AMD-K6™

MMX™ Enhanced Processor

Revision Guide

Publication # 21266	Rev: F	Amendment/0
Issue Date: September 1997

Figure 1. AMD-K6™ Processor Assertion of **HLDA** Due to Simultaneous **BOFF#**/**HOLD** Assertion

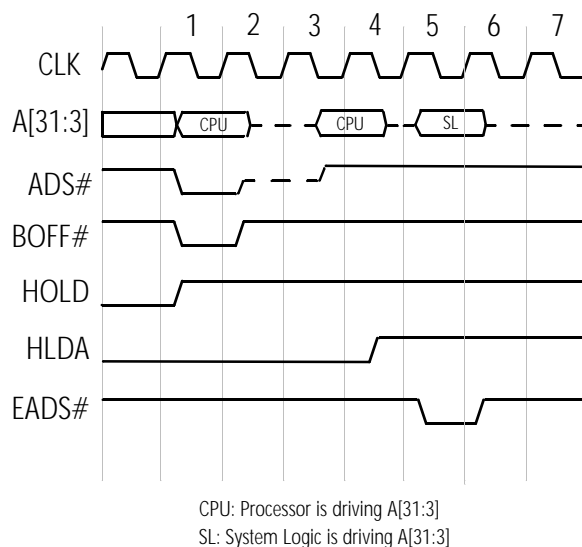
Normal Specified Operation. If **BOFF#** and **HOLD** are sampled asserted on the same clock edge that negates **ADS#**, the processor asserts **HLDA** one clock edge after **HOLD** is sampled asserted.

Non-conformance. If **BOFF#** and **HOLD** are sampled asserted on the same clock edge that negates **ADS#**, the processor asserts **HLDA** two clock edges after **HOLD** is sampled asserted.

Potential Effect on System. There are three potential effects of this erratum to consider:

- If the system logic asserts **BOFF#** for a duration of one clock, anticipates the assertion of **HLDA** in clock 3 (see Figure 1)—which is the normal specified operation—and drives the address bus and **EADS#** for an inquire cycle in clock 3, then the processor will not sample **EADS#** asserted. In addition, address bus contention will occur in clock 3.

- If the system logic asserts **BOFF#** for a duration of two clocks, anticipates the assertion of **HLDA** in clock 3, and drives the address bus and **EADS#** for an inquire cycle in clock 3, then the processor will not sample **EADS#** asserted. (No address bus contention occurs in this case.)

- If the system logic asserts **BOFF#** for a duration of one clock, anticipates the assertion of **HLDA** in clock 3, and drives the address bus and **EADS#** for an inquire cycle in clock 4, then address bus contention may occur in clock 4. (The processor will sample **EADS#** asserted in this case.)

If the processor does not sample **EADS#** asserted during an inquire cycle, cache/memory incoherency will occur. Address bus contention can affect the reliability of the processor and the system logic.

Suggested Workaround. The system logic must sample the assertion of **HLDA** before asserting **EADS#** and driving the address bus for an inquire cycle—as shown in clock 5 of Figure 1.
